RE: WC-0975 Final Amendment and Change Order Narrative (Backup)

OCWUT Project No. WC-0975 Airport Fire Suppression Extension Air Cargo Road, from Booster Station No. 11 to Will Rogers World Airport Terminal was successfully completed by Southwest Water Works, LLC by January 19, 2024.

AIRPORT FIRE SUPPRESSION EXTENSION
AIR CARGO ROAD

SHEET
C-12

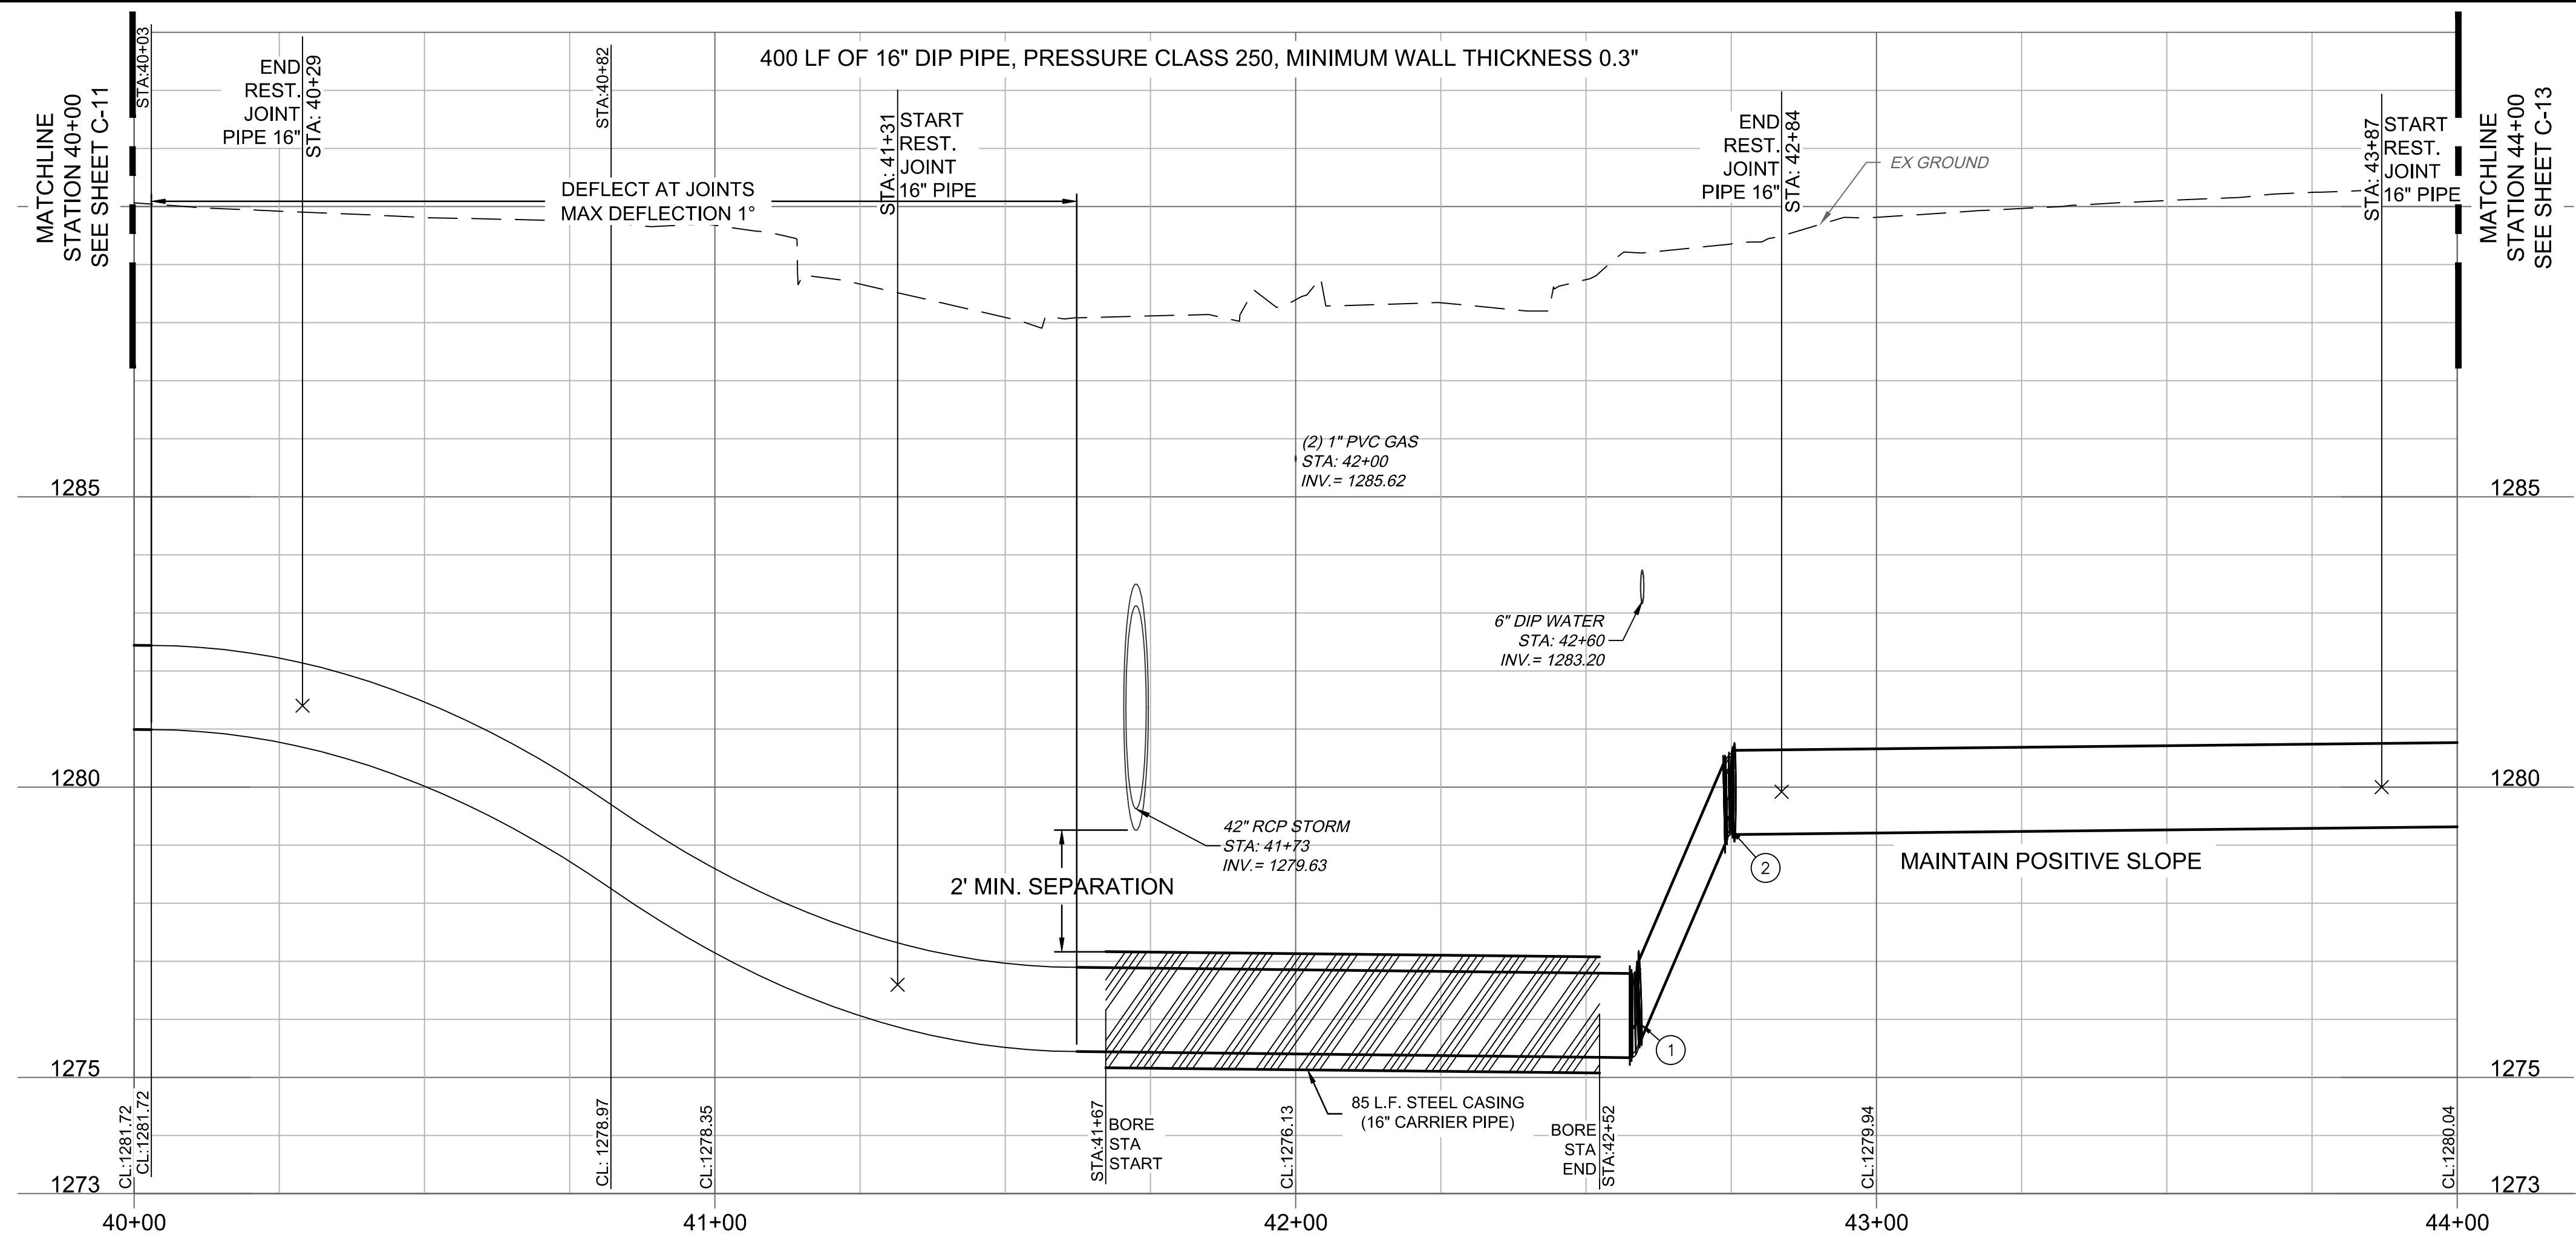
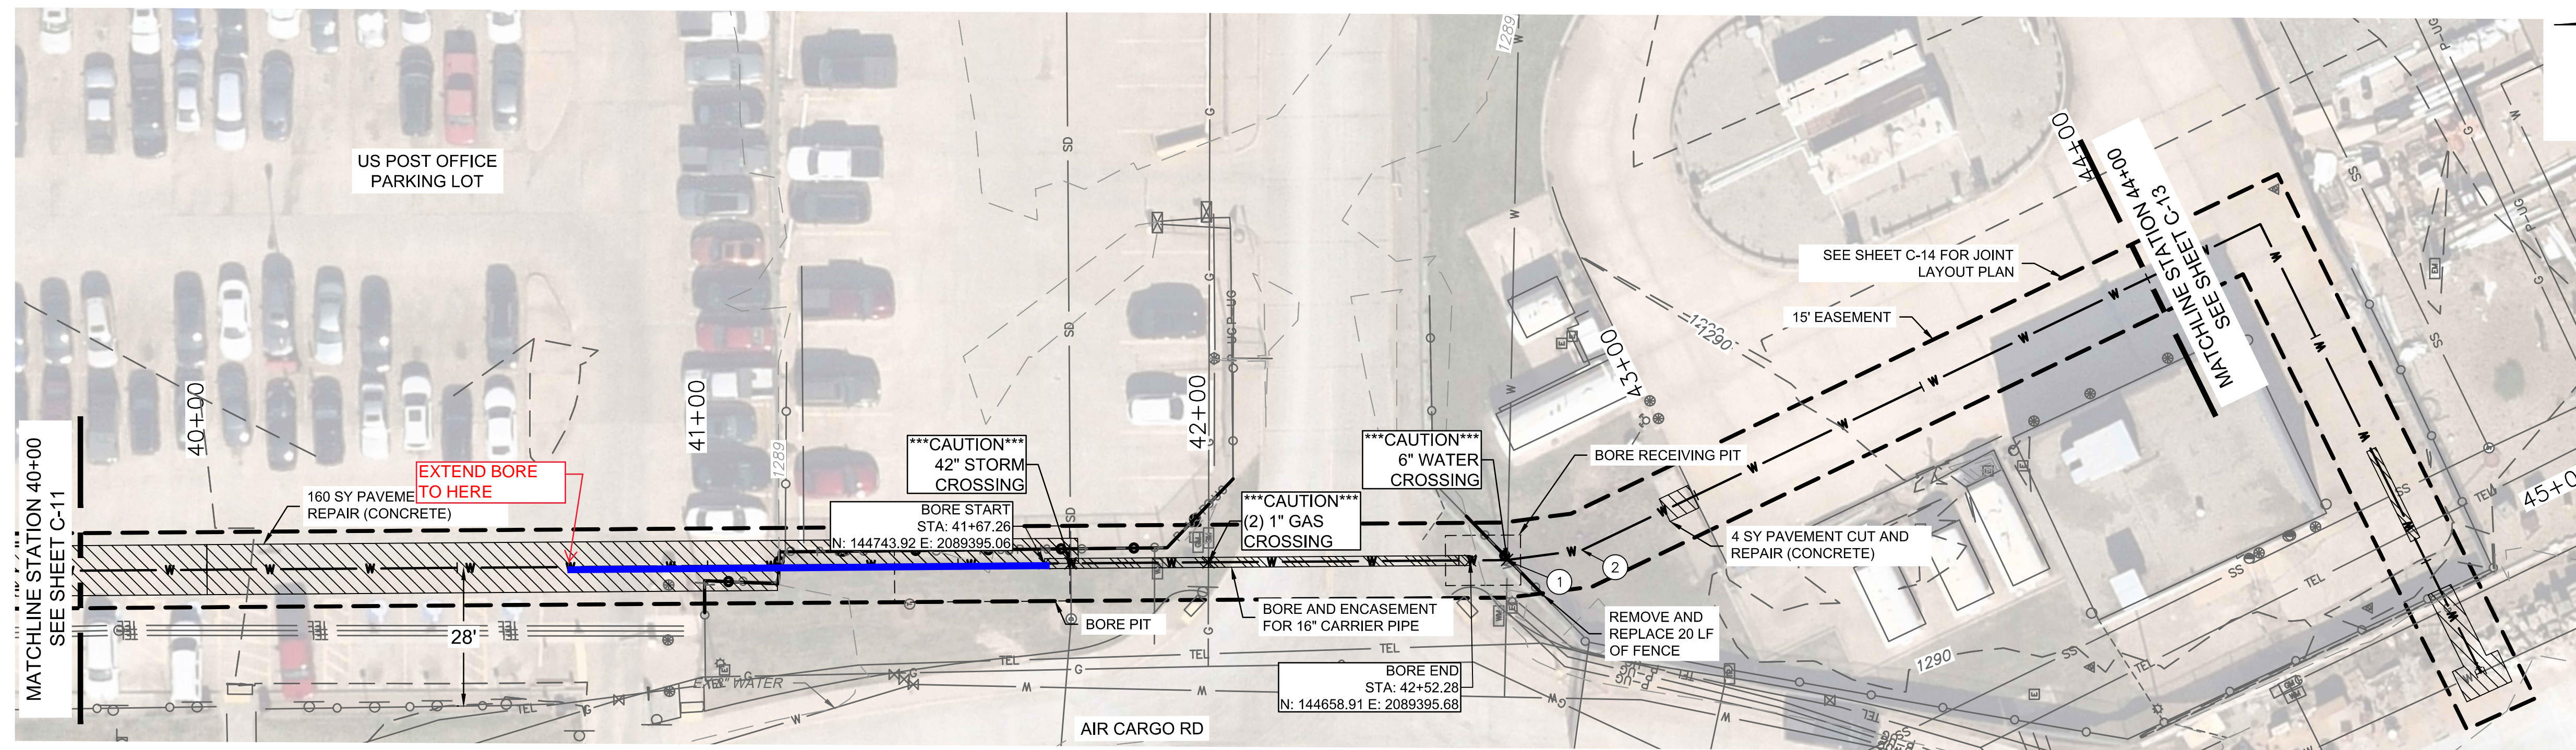
Sorry to be a pain, but I am thinking there may be another small change that we can make that will make everyone's life easier. As you can see in the picture I took and attached to this email, there is an electric line in the way of where the bore is designed to come out, which would force us to push the bore east into the parking lot and require us to take down more fencing as well as remove and replace additional concrete. My idea is to extend this bore at STA. 42+52 to the north side of the employee parking driveway which would terminate at +/- STA. 40+67, so about 100 LF additional bore. By doing this we would no longer be disrupting that entrance and will save the city on a fairly significant amount of concrete removal and replacement as well as it will help with disrupting the employee parking lot much less than we anticipated. In order to also help with costs, in my opinion, we should be able to shorten the bore that is designed to go from STA. 15+10 to STA. 16+69 by about 100 LF and still be able to bore under the storm, comms line, and sewer line. I marked up on the plans what the bores would look like in this scenario. Ultimately it should cost the city little or no money to make these changes (probably would end up saving a significant amount of money). Hopefully this all makes sense, if not, feel free to call me to discuss.

END OF BORE

Electric Line

Olsson staff have discussed the proposed bore casing changes and are currently finishing up our PDF plan revisions to share with the team and get confirmation. To summarize, everyone seems on-board with extending the 8" waterline on the south end between the encountered utilities and changing the casing to 20LF of 16"Ø steel instead of the casing diameter planned for the 16" carrier.

On the casing extension across the employee parking entrance, Olsson concurs that this casing could be extended to Sta 40+67 as proposed, with two vertical fittings added on the north side to get back up to anticipated elevation. Total casing length anticipated to be 185 LF.

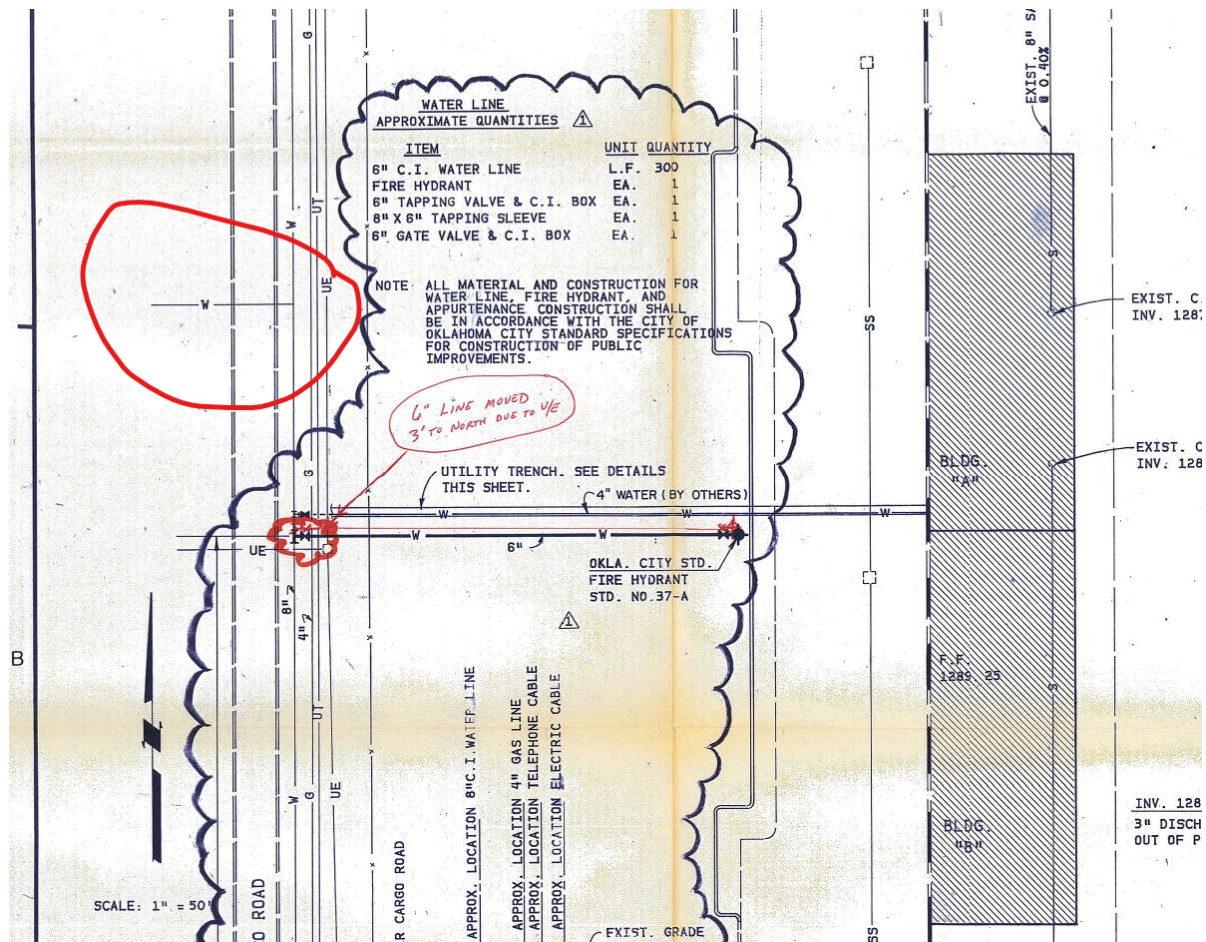
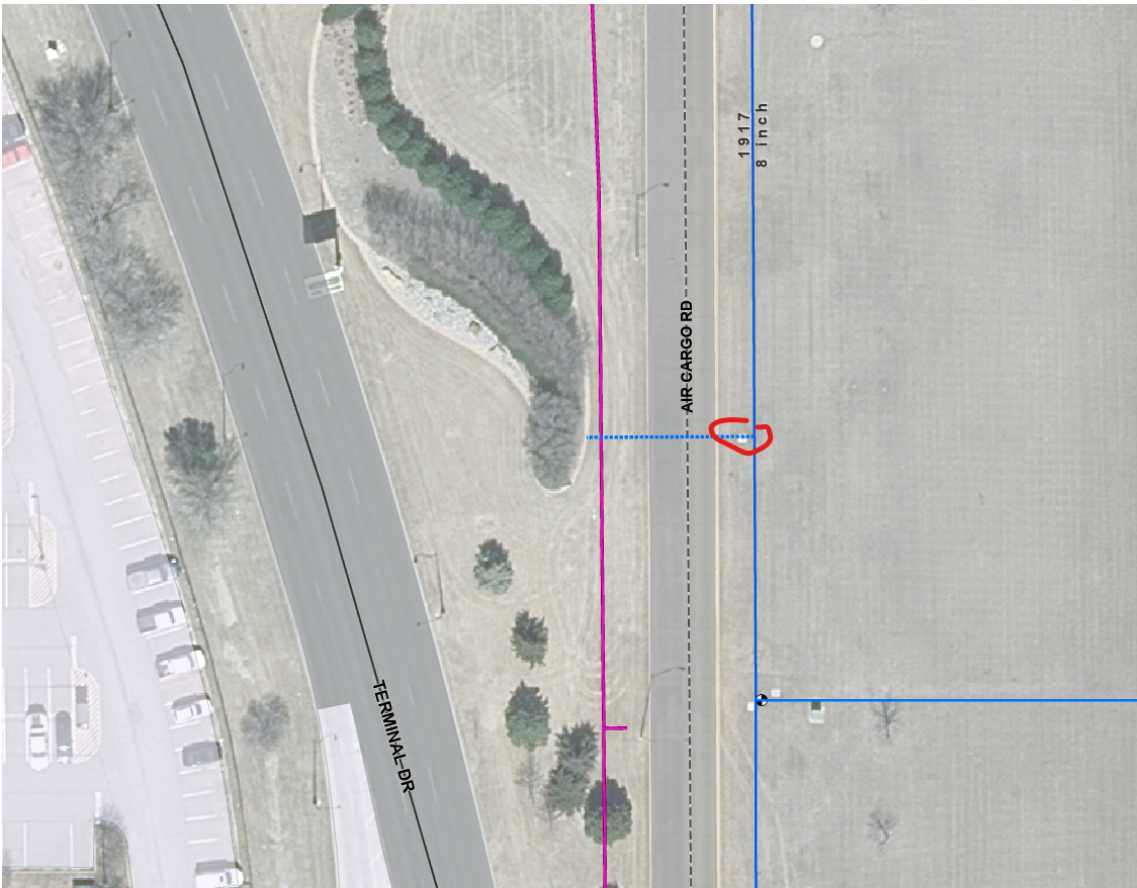
I was able to meet with Patrick with Line Maintenance, Kinney and Chad with Olsson to look at the mystery 6" waterline at STA 27+25. Attached are some pictures of mystery line and the where Line Maintenance located it. After looking

through my resources in the office, this is a 6" stub out that was installed at least before 1989 if not earlier when the N/S 8" was installed in 1973. I don't see anything back to the west that this line could possibly feed EXCEPT the irrigation around the landscaping island. I've asked Randon with Airport to see if they may possibly have some information on this.

My thoughts are to have SWWW coordinate with LM to open the hydrant at 35+50, remove the patch on the 6" and shut the valve at 27+25 on the east side of Air Cargo to make sure the Terminal stays in water and to determine if the valve controls the mystery line. If the valve shuts out the mystery line then we can coordinate with Airports to make sure nothing else in the area is shut out. From there we can decide on how to cut and cap the mystery line.

Thanks for the information. I will have the contractor cut and cap this line east of Air Cargo Rd and have it noted in the as-builts.

So, we think this is an ancient, no longer in use connection that used to feed into the irrigation system further to the west. I think we've shut it off, or we may have cut/capped it, not sure. If you want to remove part of it and cut/cap it to the west of Air Cargo Road, but east of the excavation of the water line, I don't think Airports would have an issue with that.
